June Facilities, Finance & Operations Committee Meeting

WESTON PUBLIC SCHOOL DISTRICT
UNIFORM HVAC INSPECTION AND EVALUATION
2026

RE: UNIFORM HVAC INSPECTION AND EVALUATION
Weston Public School District
Weston, CT

HVAC Ventilation Review
Weston School District
Weston High School

Priority	Medium
Tag	RTU-2
Location	A-Wing Roof
Service	A-Wing Media
Type	Multizone VAV
Outdoor Air	AFMS in door with intake louver
Filters	2 inch MERV-8
	Unit overview
	Return fan section
	Outdoor air dampers right Return air dampers left

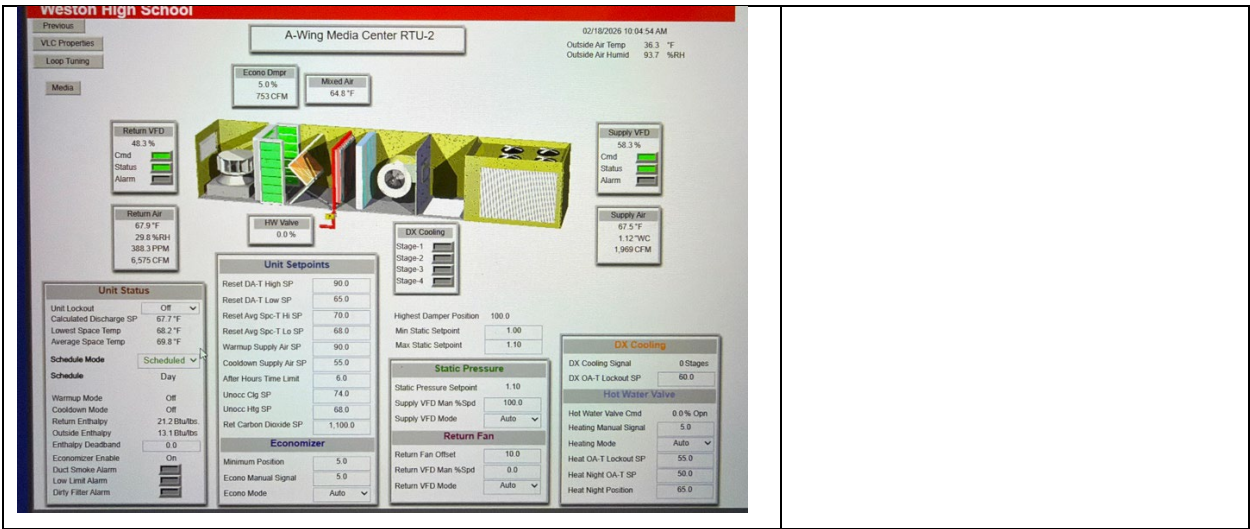
Coil inlet face. Some debris building up especially at bottom

Sum of air terminal flow is 86% of AHU design flow with SF speed at 95%							
	Outdoor air flow increases with system flow sine min damper does not reset							
	Outdoor air flow meets/exceeds design based on mixed air temperature mixing

Priority	Medium
Tag	RTU-7
Location	Roof
Service	Admin Offices
Type	Multizone VAV
Outdoor Air	Packing material at OA inlet screen has blown out
Filters	2 inch MERV-8
	Unit overview
	Inlet screen fill has broken loose – top Relief dampers – bottom (powered exhaust fan behind dampers)

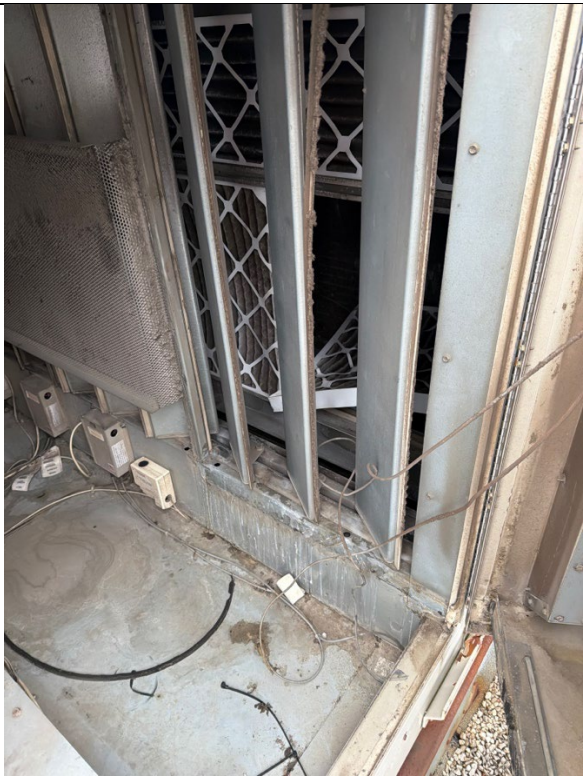
MA-T and RA-T are appear swapped on graphic
